1968 Corvette: Service Bulletin: Gas Line Rattle

Source: Chevrolet Dealer Service Information Bulletin - General Motors
Canada

Bulletin No: 68-IC-54

Date: June 29, 1968

Fig. 1.

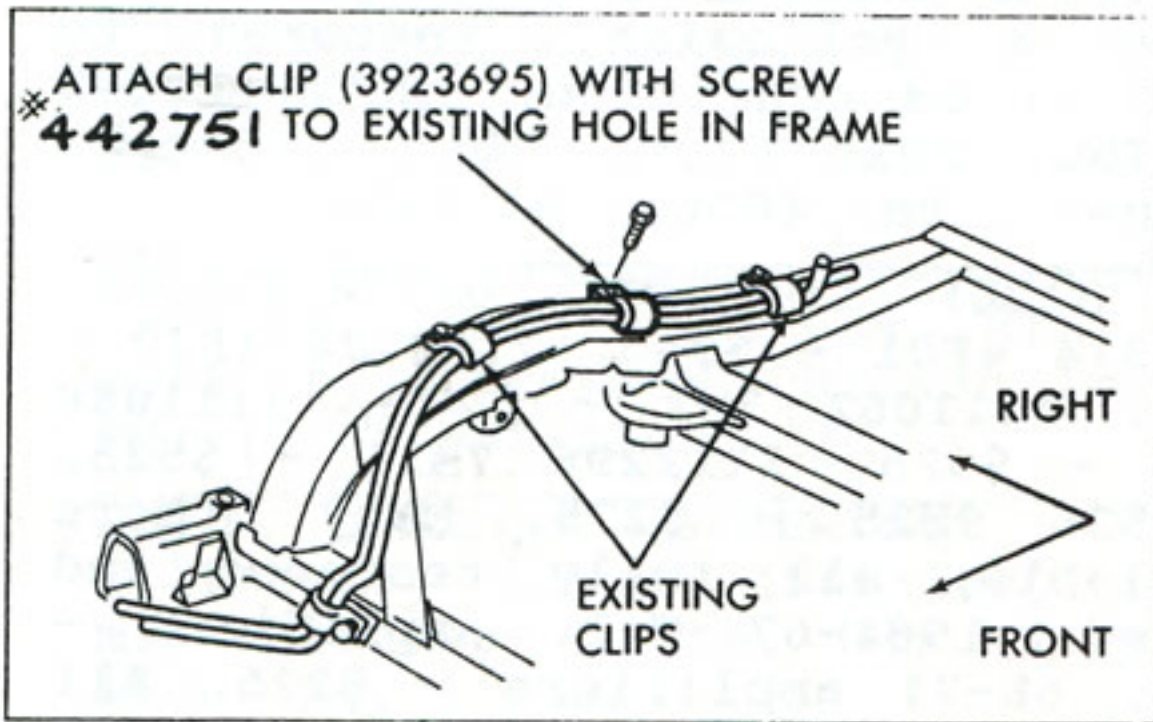
A rattling or "ticking" noise from the rear of the vehicle has been experienced on some 1968 Corvettes. This noise is resulting from the fuel supply line vibrating against the return line. Production has corrected this condition by installing an additional clip in the existing frame hole at this location. Refer to Fig. 1. This same correction is recommended for units in the Field that are experiencing the rattling or "ticking" noise. Fig. 1 illustrates where the clip should be added and gives the related parts data.
